Supplemental Type Certificate

Number: SR03317NY

Description of Type Design Change:

CERTIFICATION PLAN CP959.10

Figure 4 – Basket cross-section showing supports

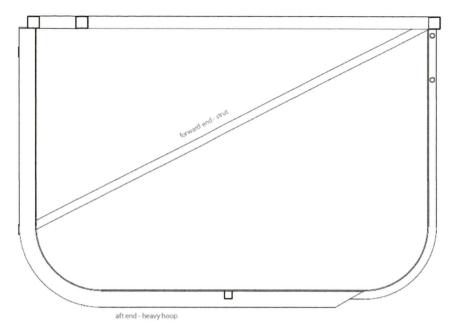
Early flight testing by Bell Helicopters determined that airflow through the basket caused vibration in the tailboom in some conditions at higher speeds, which were solved by making the lid and front end solid. As such, the approved lid assembly differs from the typical Aero Design configuration (0.75" tube rim and bracing with expanded mesh on the inside), and is instead covered with aluminum checker plate riveted to the rim instead of expanded mesh. The forward end of the basket is covered with a flat aluminum sheet, riveted to the hoop and rim, instead of expanded mesh.

Figure 6 - New Attachment Provisions

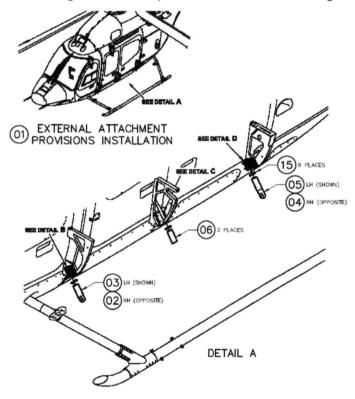
The altered configuration requires new attachment fittings that are inserted into the existing sockets for the steps. It is not feasible to maintain the original attachment positions. The new fuselage attachment points are inboard of the original configuration.

Figure 6 - New Attachment Provisions

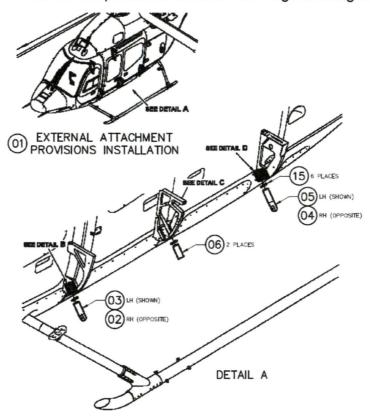
The altered configuration requires new attachment fittings that are inserted into the existing sockets for the steps. It is not feasible to maintain the original attachment positions. The new attachment position is inboard of the original configuration.
